**EXPERT REPORT**

Opinion re “Expert Report of Mark Jacobson, Ph.D.” April 6, 2018

*Kelsey Cascadia Rose Juliana, et al. v. United States of America, et al.*

August 13, 2018

Figure 1

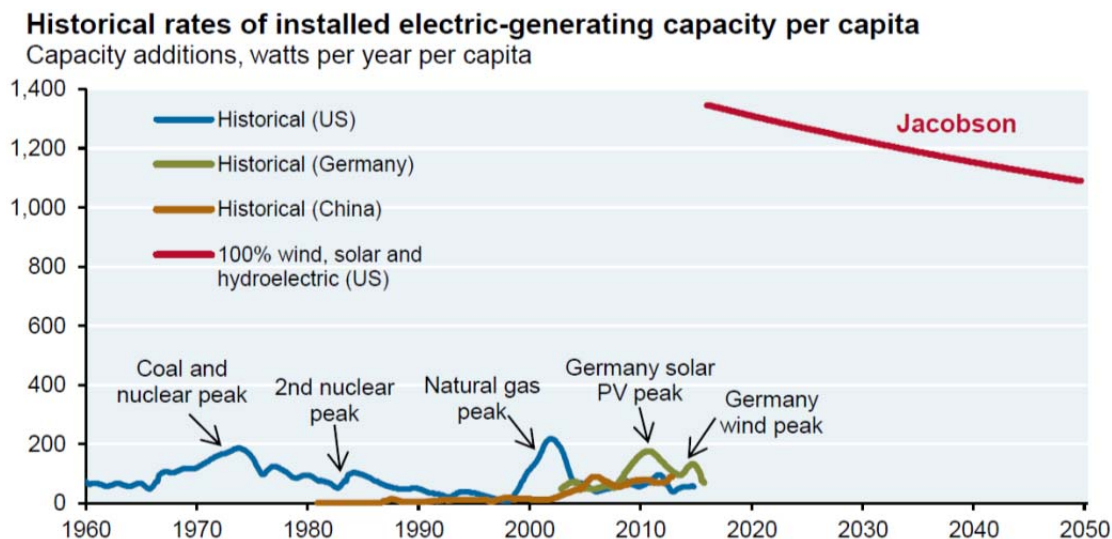
Figure 1 below supports my contention that the build-out necessary to meet Jacobson's proposed transition to 100% WWS by 2050 is an order of magnitude greater on a per capita basis than recent build-outs undertaken by the U.S., Germany, and China.

In my expert opinion, the timelines posited by Jacobson to build, install, and deploy the necessary facilities and infrastructure to transition the United States energy infrastructure to a proposed 100% WWS energy system are unrealistic and, in my opinion, infeasible.

Figure 2. Six-year time series comparison of energy storage changes used to align electricity demand with electricity supply per Jacobson et al. (2015b)

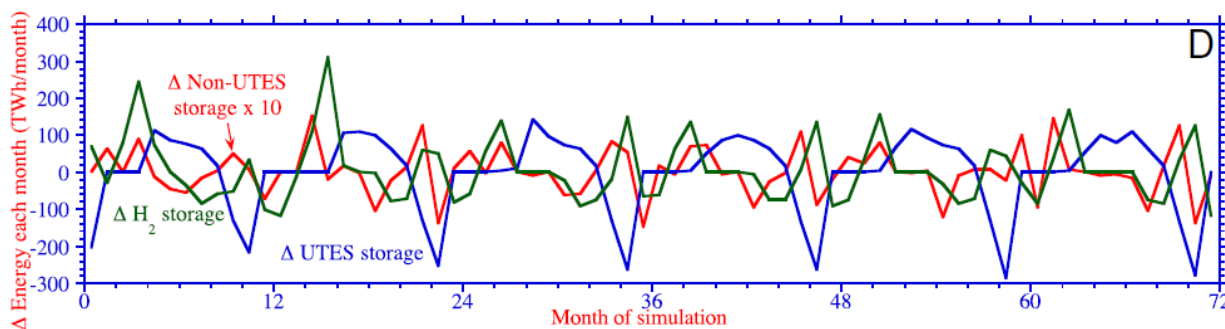
Jacobson et al. (2015b) documents that LOADMATCH uses several energy storage technologies to align electricity demand with electricity supply. As shown in Figure 2, (reproduced from Jacobson et al., 2015b (page 15062), Jacobson et al. (2015b) rely primarily on hydrogen storage and underground thermal energy storage (UTES) as their storage mechanisms to ensure sufficient supplies of electricity exist to meet demand for electricity at all times. Therefore, I focus my assessment on these two technologies. I summarize my analysis of these systems below, with additional detail provided in Appendices C and D for hydrogen storage and UTES, respectively.

*Figure 3. Photo of the Drake Landing Solar Community*

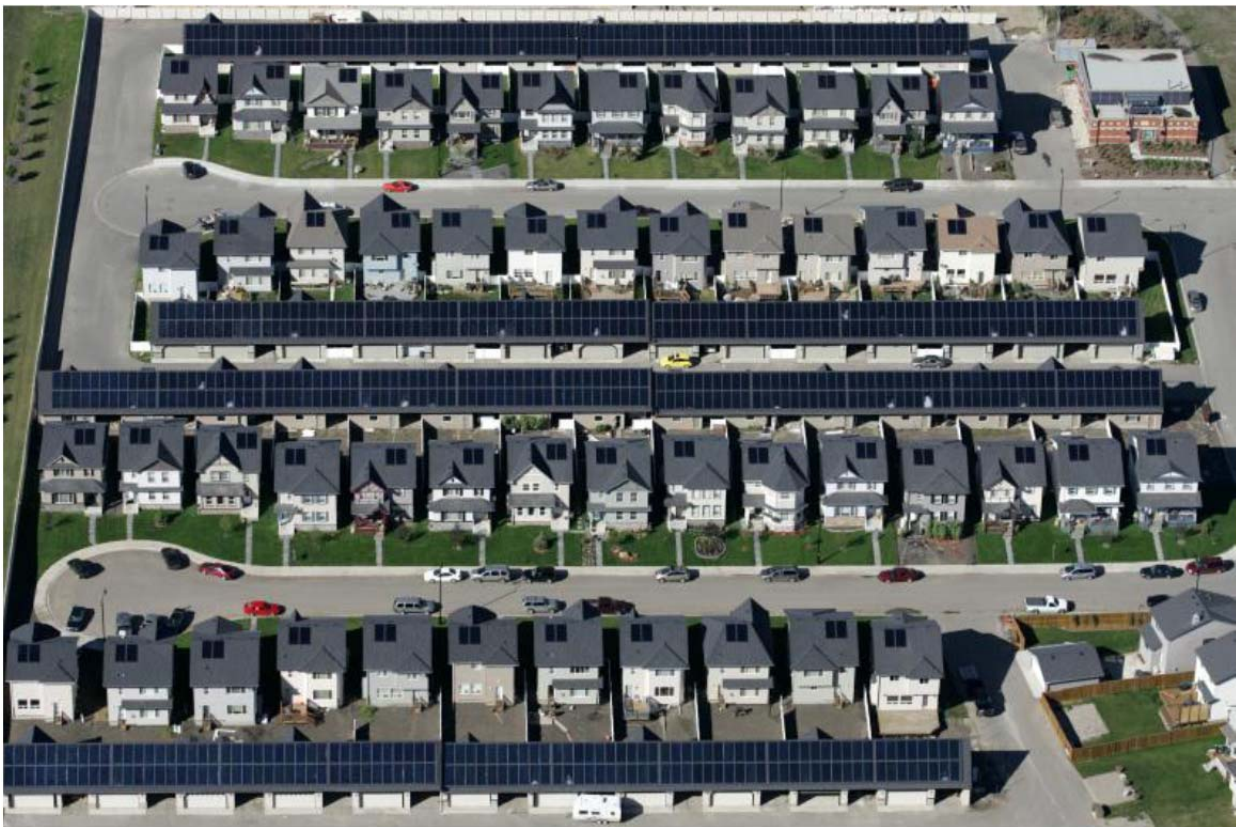
Jacobson's basis for UTES deployment and functionality is the Drake Landing Solar Community (DLSC), a planned community of 52 homes in Canada.

Based on this concept, Jacobson assumes that 85% to 95% of all air and water heating in the United States will be realized from energy stored in UTES.<sup>15</sup> Achieving this objective requires UTES systems to be retrofitted to tens of millions of homes in the United States. For reference, a picture of DLSC is included below as Figure 3. The picture shows the large area required for solar thermal panels. It also shows a lack of trees in the community, as this would block sunlight. For efficiency, homes in DLSC are spaced closely together. Not pictured, but present, are the 144 boreholes in the community that give access to the underground storage reservoir.

Jacobson offers insufficient justification or analysis to support his claim that 85% to 95% of all air and water heating in the United States can be realized from energy stored in UTES. Neither in his Expert Report, nor in his articles underpinning his Expert Report, does Jacobson address questions as to whether DLSC can be replicated on a large scale within the United States. Specifically, Jacobson provides no response to:

Figure 4. Net Daily Coefficient of Performance (COP)

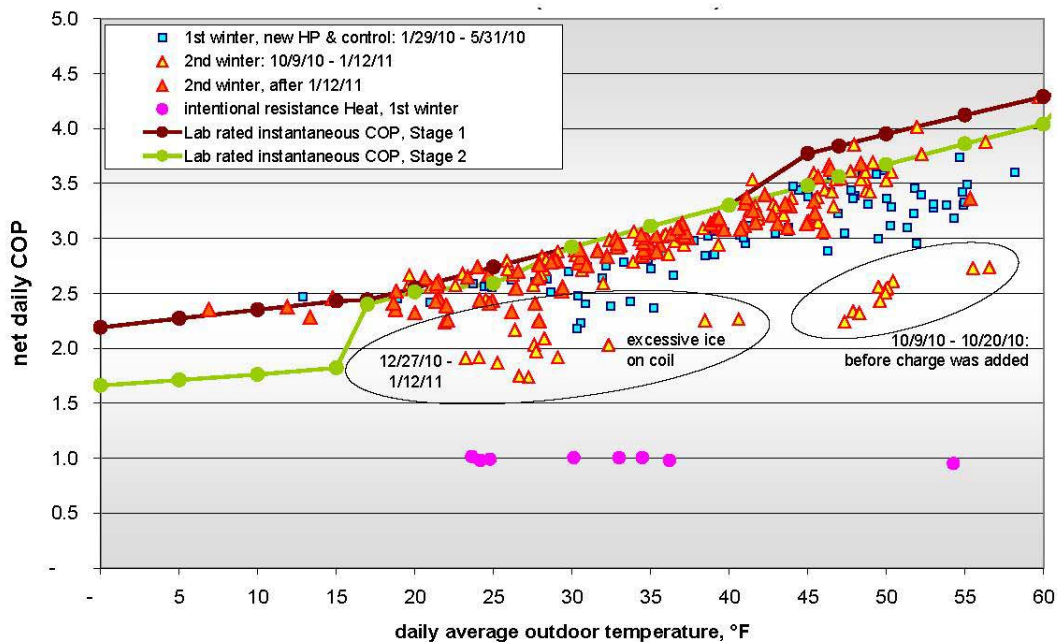
for each month in his model. In my view, the use of these historically average temperatures does not capture extreme weather events, because, among other reasons, smoothing these temperatures over a month's time horizon eliminates the spikes in temperatures, and the associated spikes in energy demand.

An example of extreme weather conditions is bitter cold over much of the US for an extended period of time, as occurred during the polar vortex (January 2014) or the cold snap last winter (December, 2017- January 2018). Temperatures were well below average by 10 degrees, 20 degrees, or even more in some places.<sup>25</sup> The obvious direct effect of lower temperatures is the demand for more heating, as well as strain on the performance of energy systems. For example, the efficiency of heat pumps (see Figure 4 below) is measured by the coefficient of performance (COP), which declines substantially in the cold. At 0°F, a heat pump requires about twice the electricity per unit of heat delivered as that required at 40°F. At subzero temperatures, which were present during these cold snaps, the efficiency degrades even more.

Figure C-1.

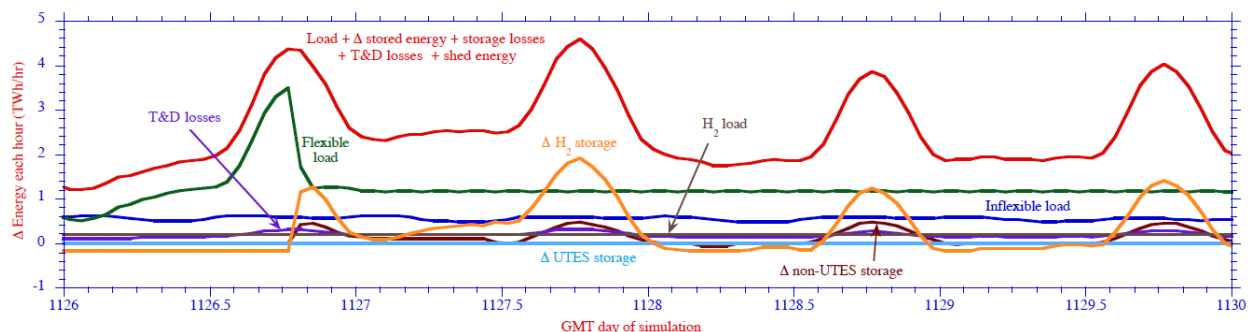
To calculate electrolyzer costs, Jacobson et al. (2005) uses capacity factors, referred to as “fraction of time electrolyzer used.”<sup>43</sup> These capacity factors are 95 percent for the “low value” case and 50 percent for the “high value” case.

However, this is in contradiction to the figures presented in Jacobson et al. (2015b). Specifically, the third panel of Figure S6 on page 19 of the Supporting Information to Jacobson et al. (2015b) is reproduced below as Figure C-1.

In this figure, the electrical load going to the hydrogen storage system is represented by the orange line. The load going to the hydrogen storage system is shown to be about 2 terawatt-hours per hour (TWh/hr), or 2,000 gigawatts (GW). In Jacobson et al. (2015b), page 15061, Table 1, the average load for the system is listed as 180.2 GW.<sup>44</sup>
